20192018L011Rev4

DEM REFERENCE 2024D131832: RESPONSE TO FURTHER INFORMATION REQUEST

Tonkin has been engaged by Sandyridge Holdings Pty Ltd (Sandyridge) for the purpose of supporting the mining lease application at the company's Compton (formerly Buter's) Sandpit site. Our scope includes assisting with the response to the Department of Energy and Mining's (DEM) information request regarding the mining lease application over mineral claim (MC) 4537.

Attachment 7 – Updated Figure 6

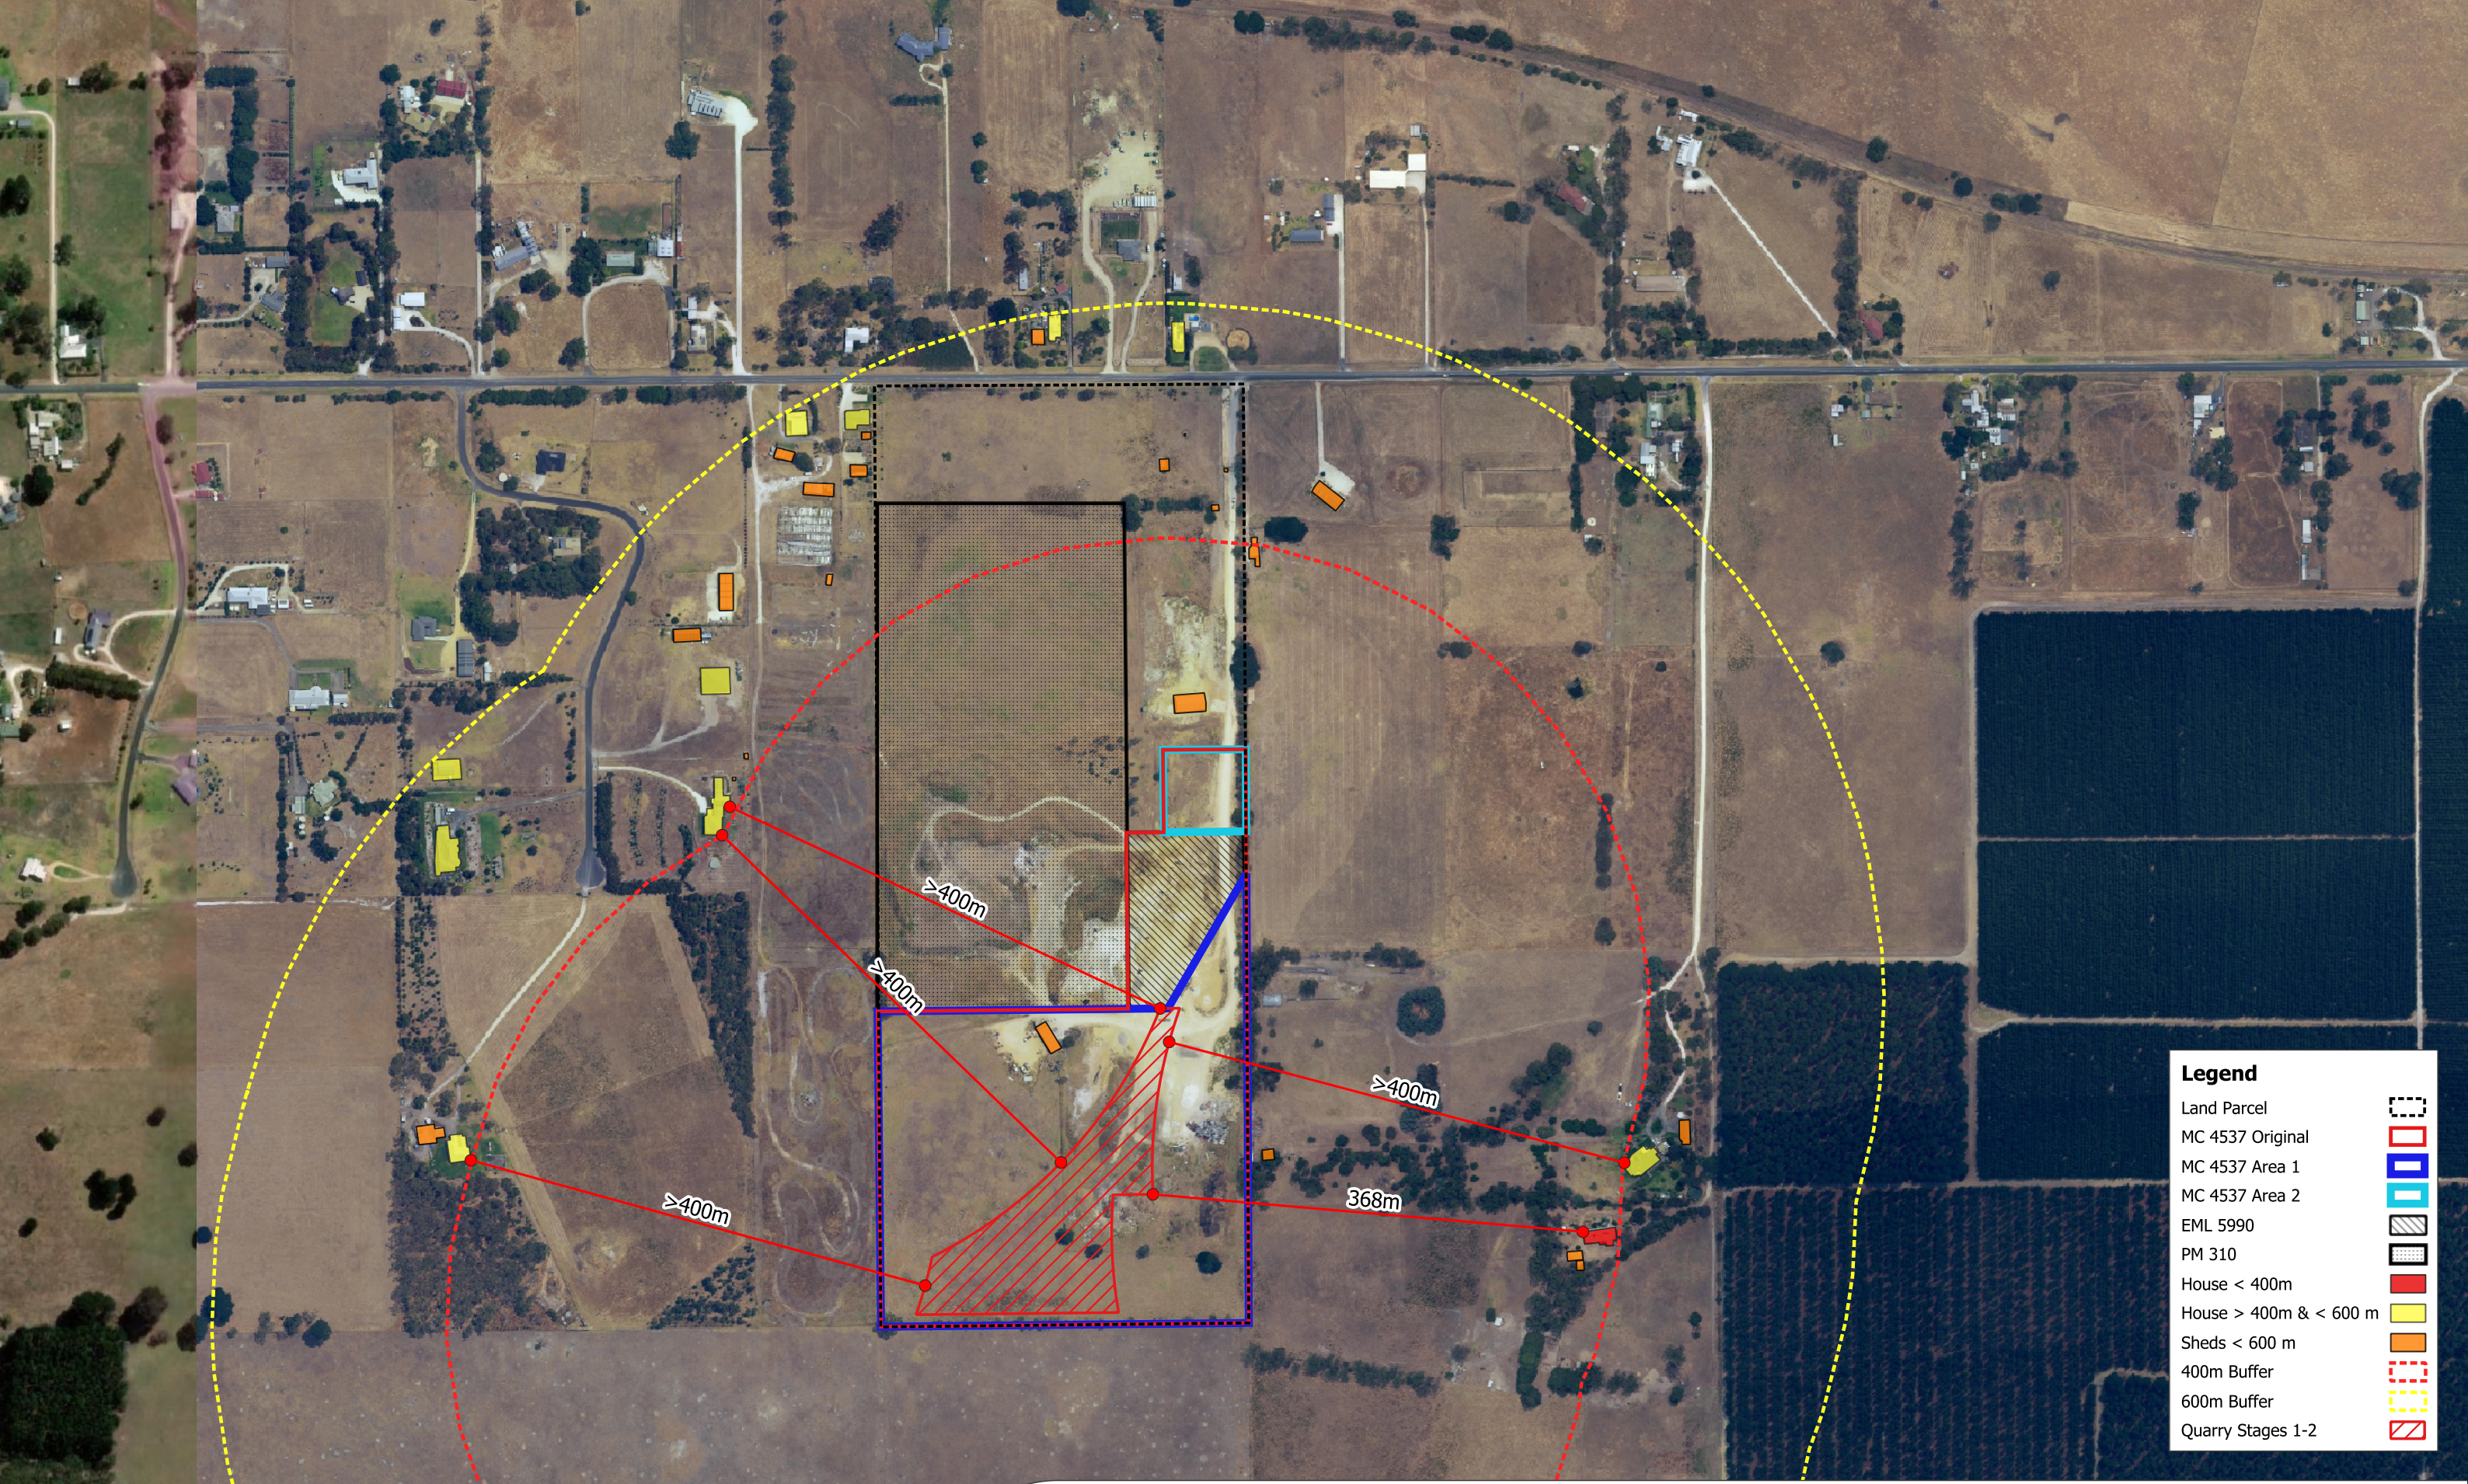
6.	Response to Public Submission - Land Access Map - Figure 6	<p>Public submissions from Ms Loxton and Ms Moreland identified errors in the Figure 6 land access map in identifying adjunct structures – houses and sheds.</p> <p>The submission from Ms Loxton identified that a house is incorrectly labelled as a shed, and another shed has not been identified on the map.</p> <p>Submission from Ms Moreland identified that there are two residences on their property.</p>	<p>Provide an updated Figure 6 which accurately maps the houses and sheds in the surrounding areas.</p>	<p>An updated Figure 6 is provided in Attachment 7.</p>

Attachment 12 – Figure 13 Additional Bunding and Screen Planting Plan

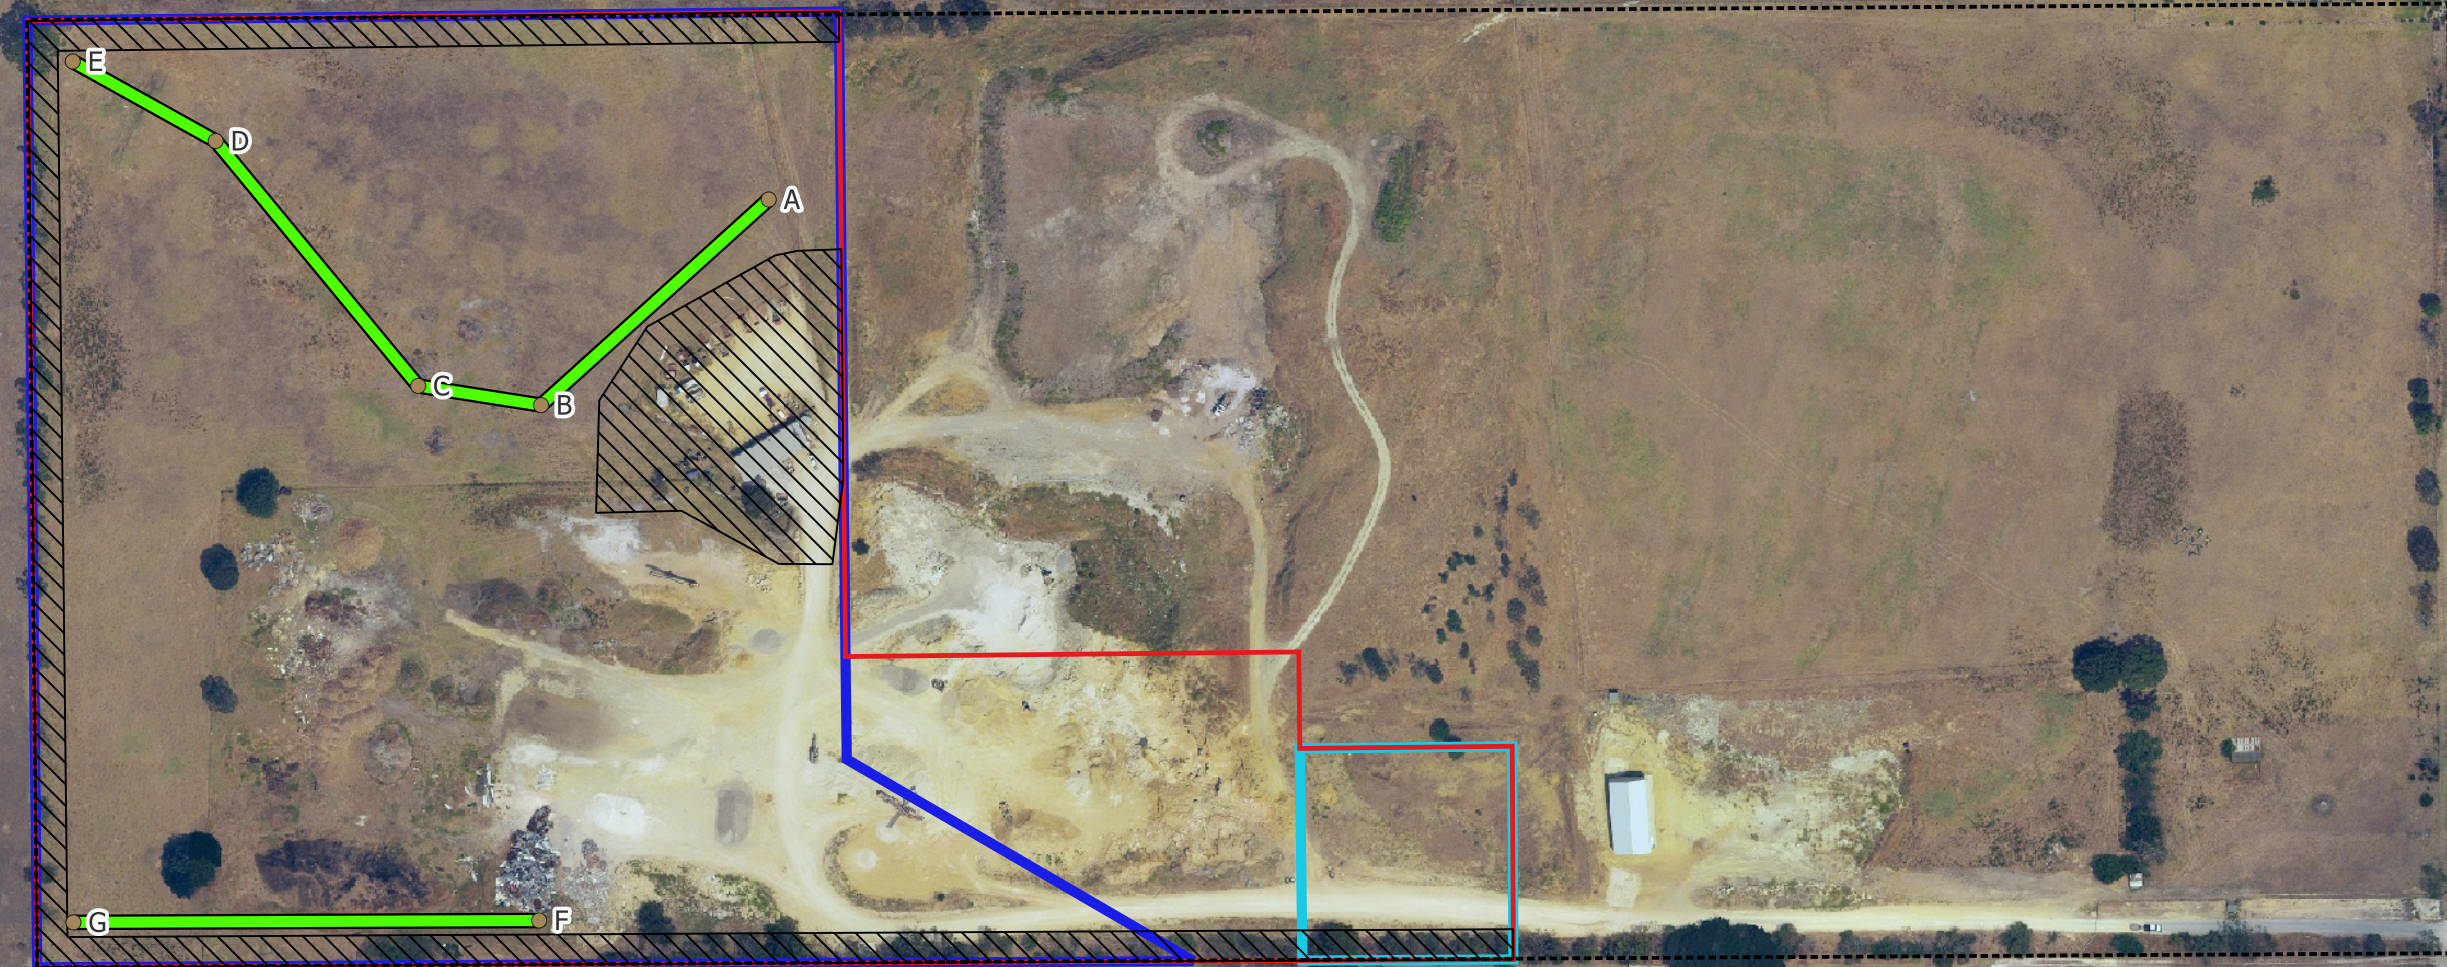
#	Section	Comment on Response Document	Further Information Required	Sandyridge's Response
7.	Response to Public Submission - Visual Impact	<p>All public submissions raised concerns about the visual impact from the surrounding properties.</p> <p>The Mining Lease Proposal states that the existing tree screen partially encloses the property boundaries and recently planted tree screen along the southern and western boundaries are anticipated to completely screen onsite operations in 5-10 years. The natural topography also obstructs the view from some locations.</p> <p>Further information is required to demonstrate that the proposed outcome could be achieved using this strategy.</p>	<p>Provide a map indicating where the proposed tree screen will be located.</p> <p>Provide further information on the species of trees to be planted, the density of plantings, when the trees will be planted and proposed monitoring and maintenance of the tree screen.</p>	<p>Please see Attachment 11 for the photographs of the tree plantings undertaken on 15 June 2023. The species of trees planted include two varieties of Callistemon (2m spacing) as well as Acacias (4m spacing). Plantings were undertaken in 2 rows in a front to back formation meaning that once trees are fully grown they should each overlap by 1m. All varieties are classed as "Kangaroo non palatable". The Callistemon Varieties are expected to be 2m x 2m and 1.5m x 1m and the Acacias are expected to be 4m x 4m when fully grown.</p> <p>The plantings are currently subject to a 2 year maintenance period which involves a fortnightly visual inspection of all plants, stakes and shrouds for any maintenance requirements as well as twice yearly spot spraying to keep other vegetation down whilst the new plants are establishing. Additional screen plantings and bunding are to occur as quarrying activities progress. These additional screen plantings and bunding will be located across the crest of the hill at the south western area of the property and along the south eastern fence line, as shown in Figure 13 provided in Attachment 12.</p>

Attachment 14 – Updated Figure 12

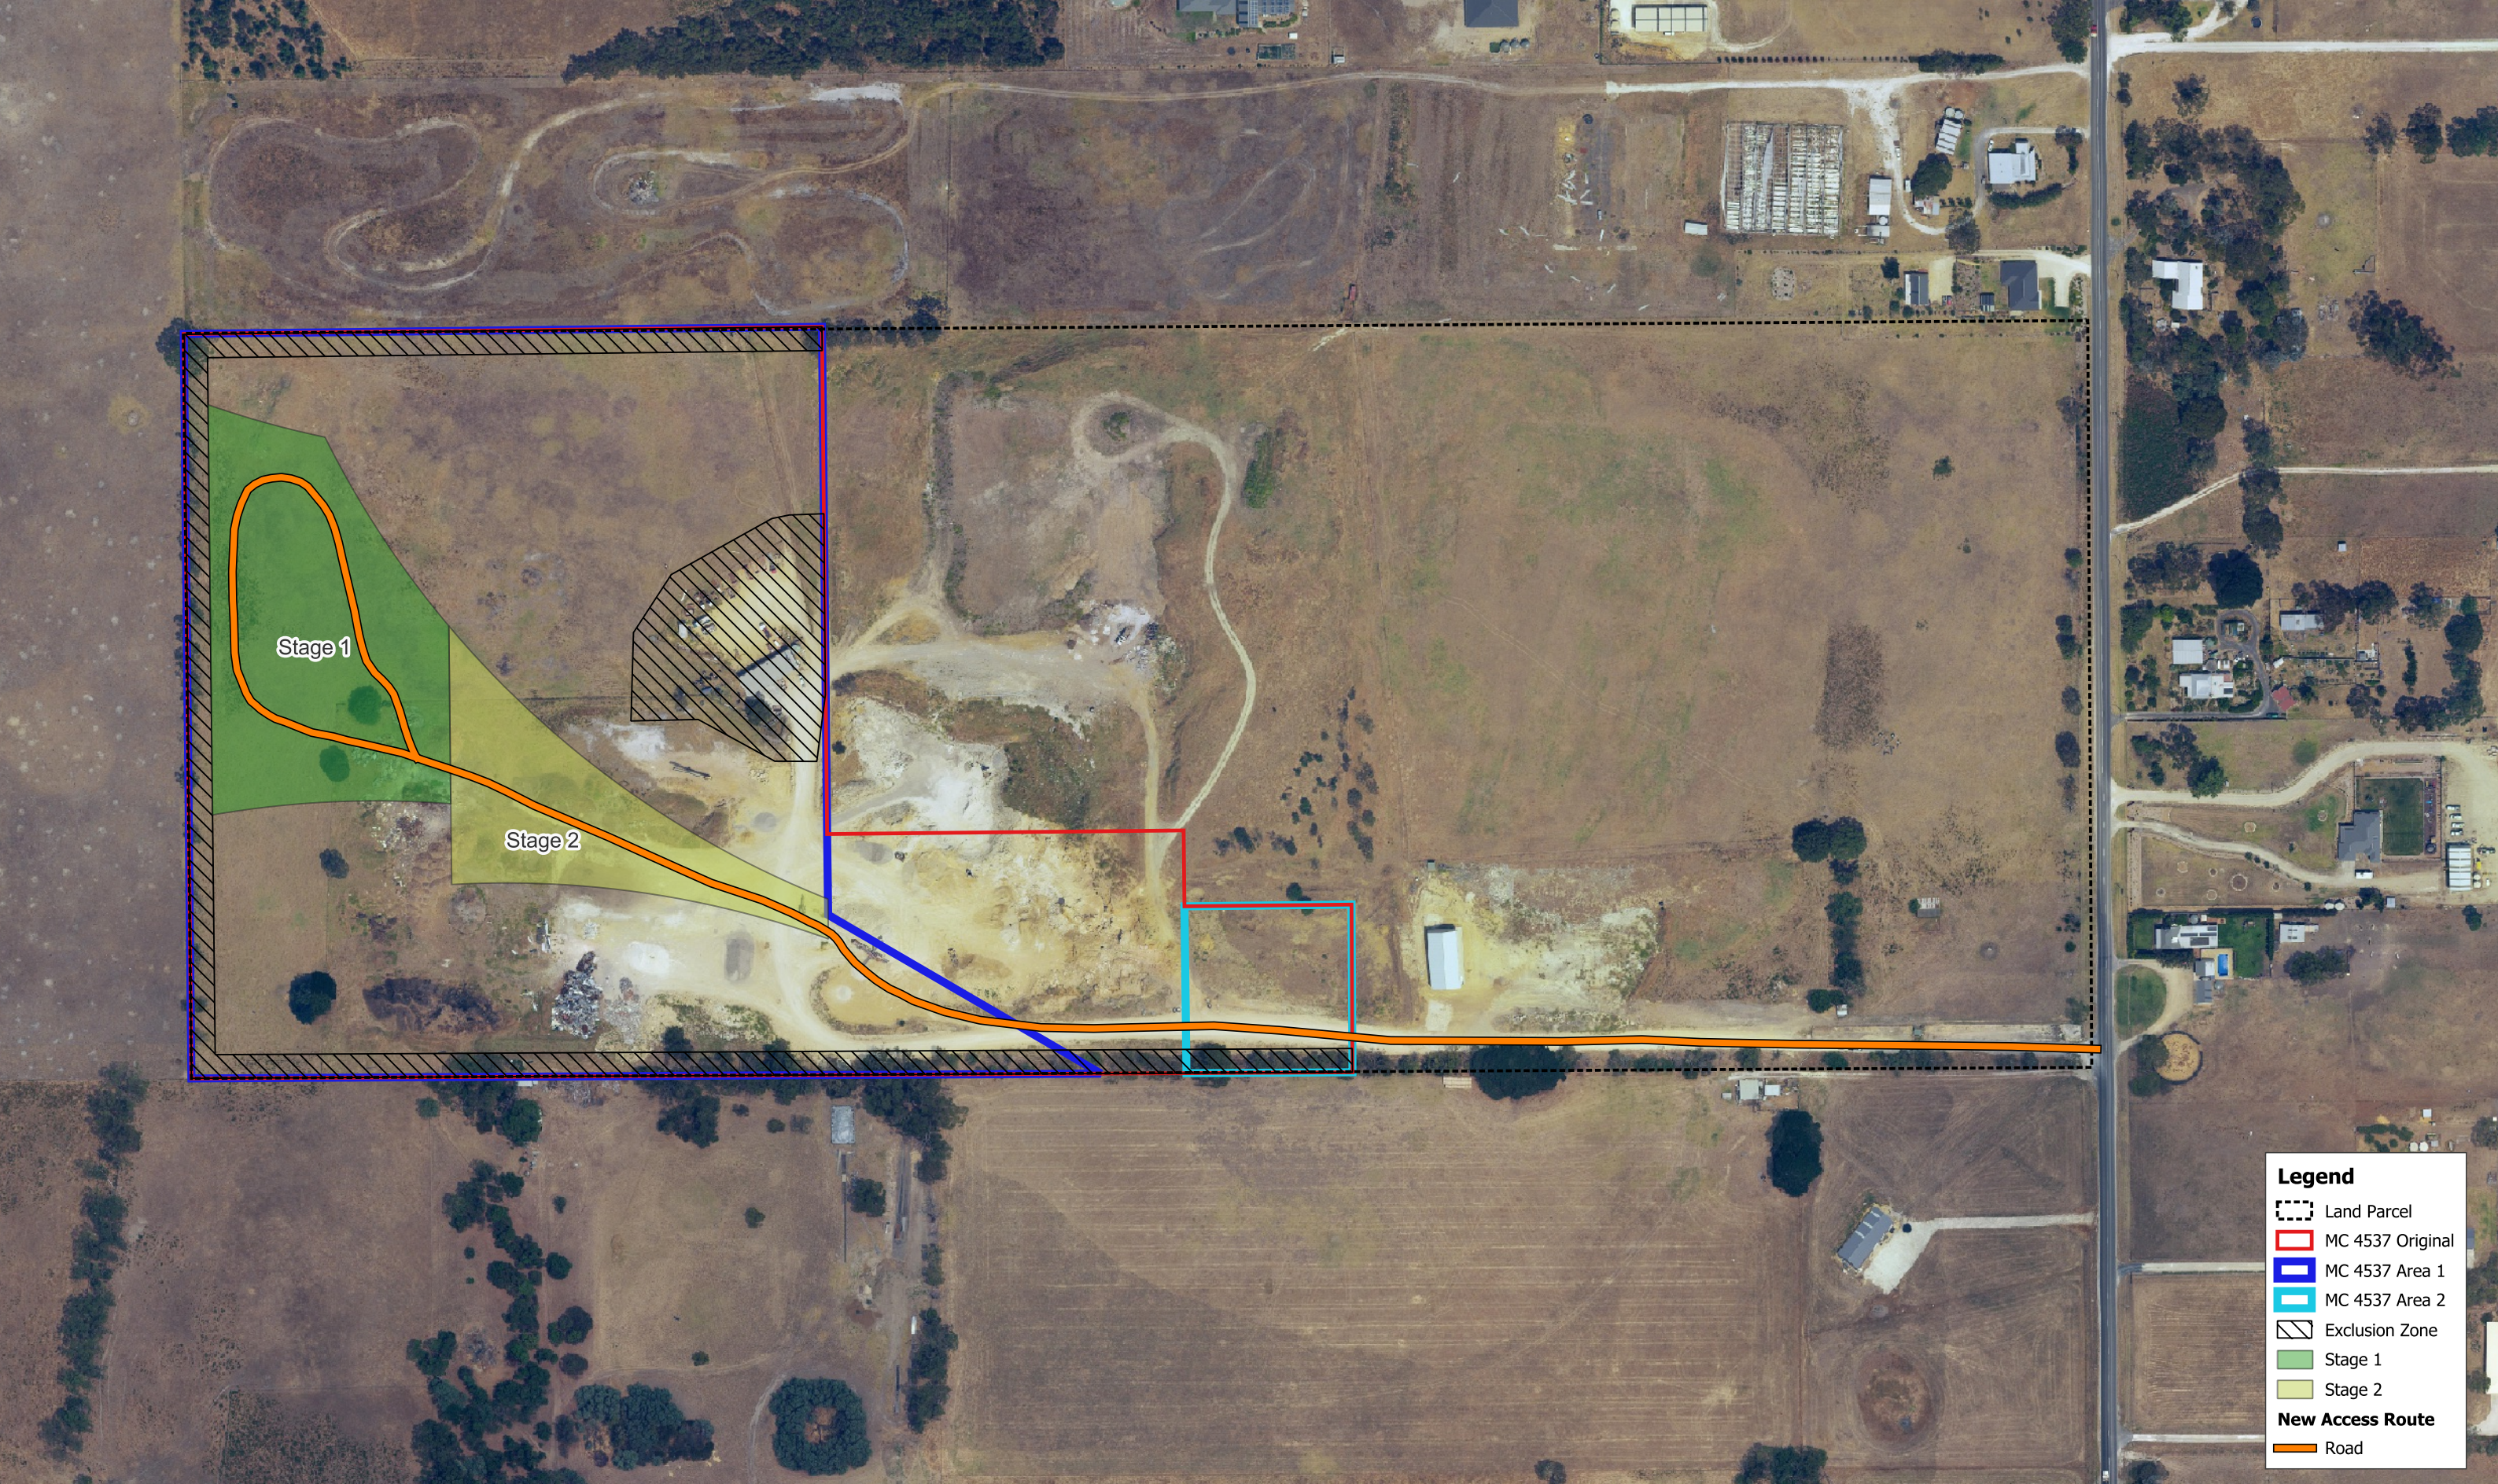
#	Topic	Description of Matter Raised by SA Government	Further Information or Clarification Required	Sandyridge's Response
		quarry operations or waste operations. As this site is both a quarry and a waste receipt site, it is important that the different stockpiles are clearly identified.		
7	4.5.1 Access & Roads	In this section of the MP, it states: a private access road runs along the eastern boundary of the property. This is also depicted in the Access Route Map on page 35, referred to as Figure 12. In section 4.3.2 Sequence of Quarrying and Progressive Rehabilitation, it describes mining progressing from Stage 1-3. The mine plan shows that the access road will be excavated as mining progresses through stage 1 to 3.	Clarify the access road route throughout the life of the mine.	An updated Figure 12 is provided in Attachment 14. The portion of the existing private access road along the eastern boundary will remain for the life of the mine. A portion of the existing access road that runs east-west across Stage 1 will be inaccessible during mining operations in Stage 1 but will be reinstated following rehabilitation. During this time, an alternative access road will be operational along the western boundary of Stage 1 as indicated on the revised Access Route Map (Attachment 11).
